Datum/Date 8/8/2018

## Product Change Notification

Miniature Switch Series D4 with temperature rating T85

**9.Example Images**

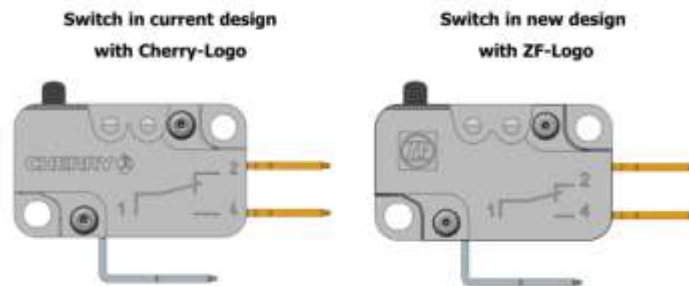
- As part of our re-branding from Cherry to ZF we will change our brand logo on the switch housing.  
The new Logo will be "ZF" (see Example Images point 9)
